ST. LUCIE PLANT UNIT NO. 2

AMENDMENT TO FACILITY OPERATING LICENSE

Amendment No. 7
License No. NPF-16

ATTACHMENT TO LICENSE AMENDMENT NO. 7

FIGURE 5.6-1
INITIAL ENRICHMENT VS
BURNUP REQUIREMENTS FOR STORAGE OF
FUEL ASSEMBLIES IN REGION II

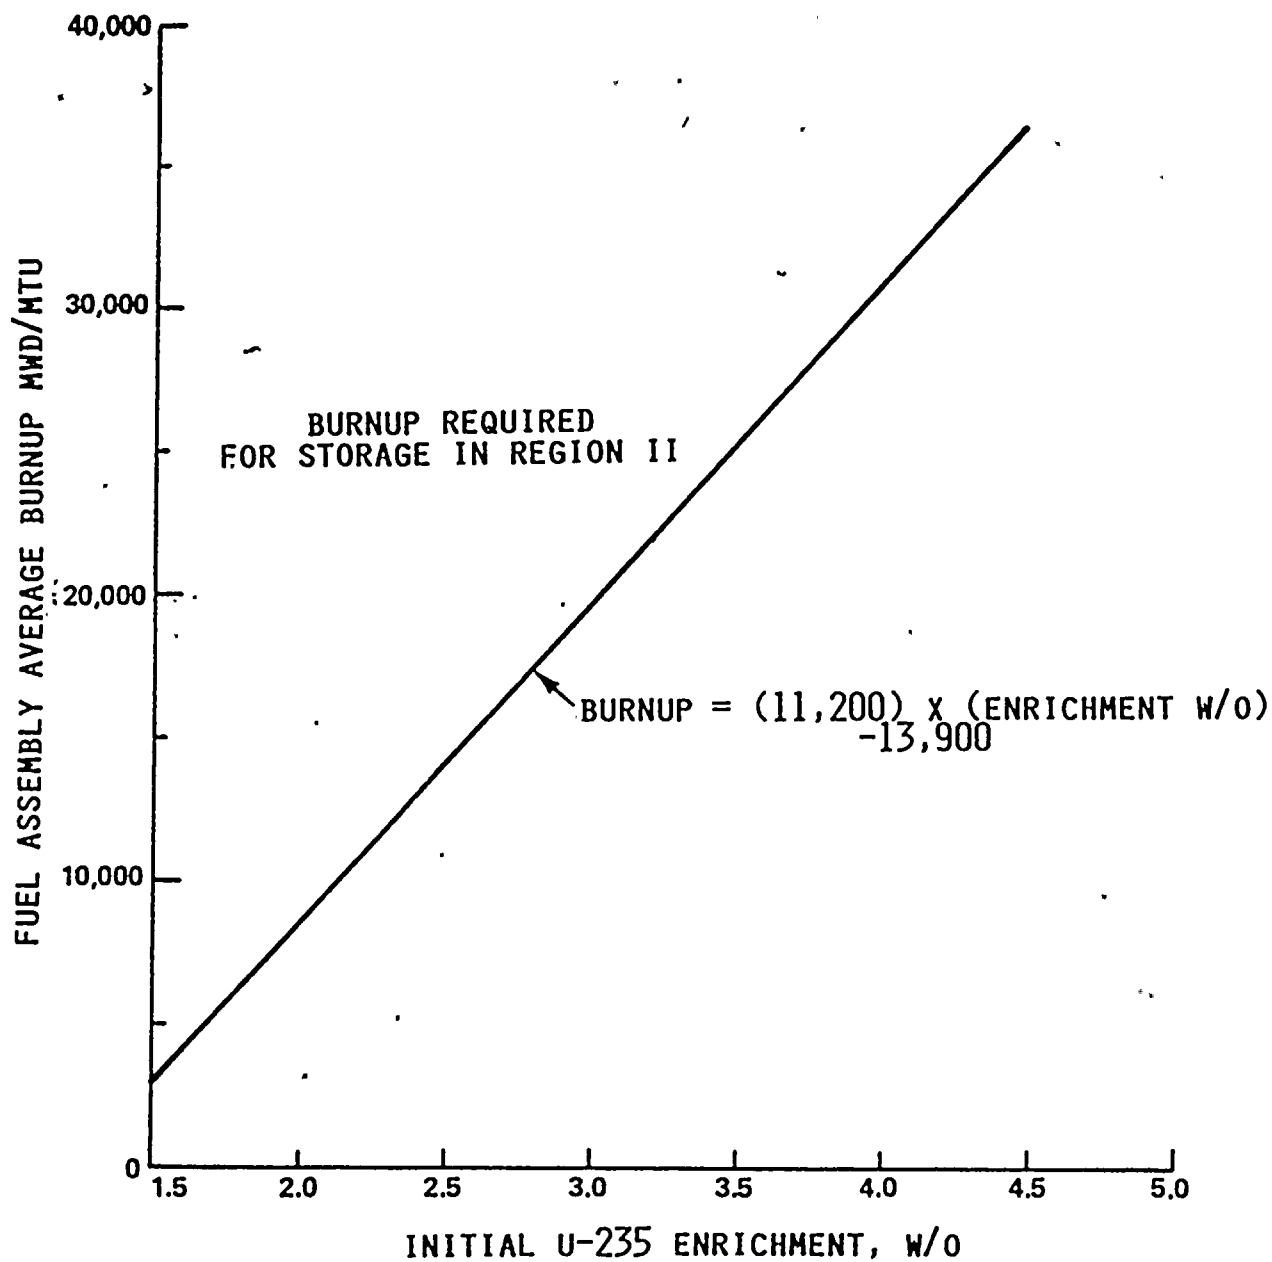
Region I can be used to store fuel which has a U-235 enrichment less than or equal to 4.5 weight percent. Region II can be used to store fuel which has achieved sufficient burnup such that storage in Region I is not required. The initial enrichment vs. burnup requirements of Figure 5.6-1 shall be met prior to storage of fuel assemblies in Region II.
